Bulletin: Q-137R1

## 2007 F53 Canadian Daylight Running Light Revision

**Note:** *This bulletin is being revised to correct the Daylight Running Light relay part numbers*

Figure 1

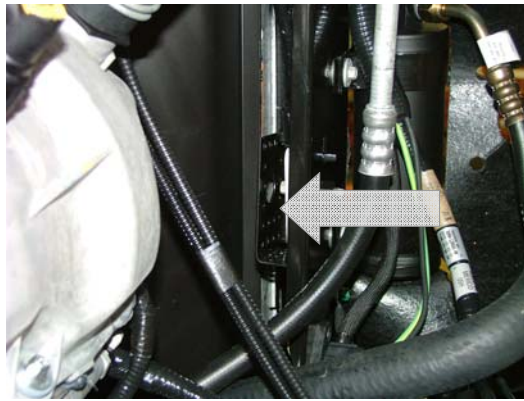
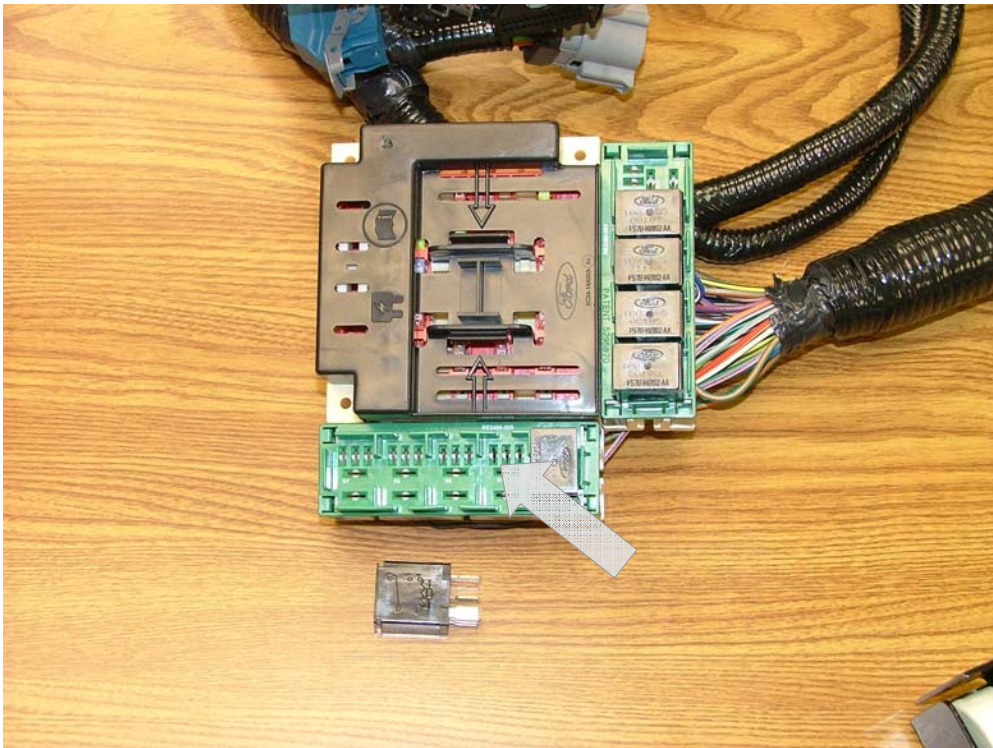
- Mount the DRL Resistor to the inside of the radiator support by tightening the captive bolt on the DRL Resistor to the weld nut provided on the radiator support. Refer to Figures 1 & 2. Orient the DRL Resistor with the connector "up". Note that clearance is minimal and a 10mm open-ended wrench will be necessary to tighten the bolt. Caution: The DRL Resistor gets hot when the daylight running lights are "on". Do not use an alternate mounting method or location for the DRL Resistor.
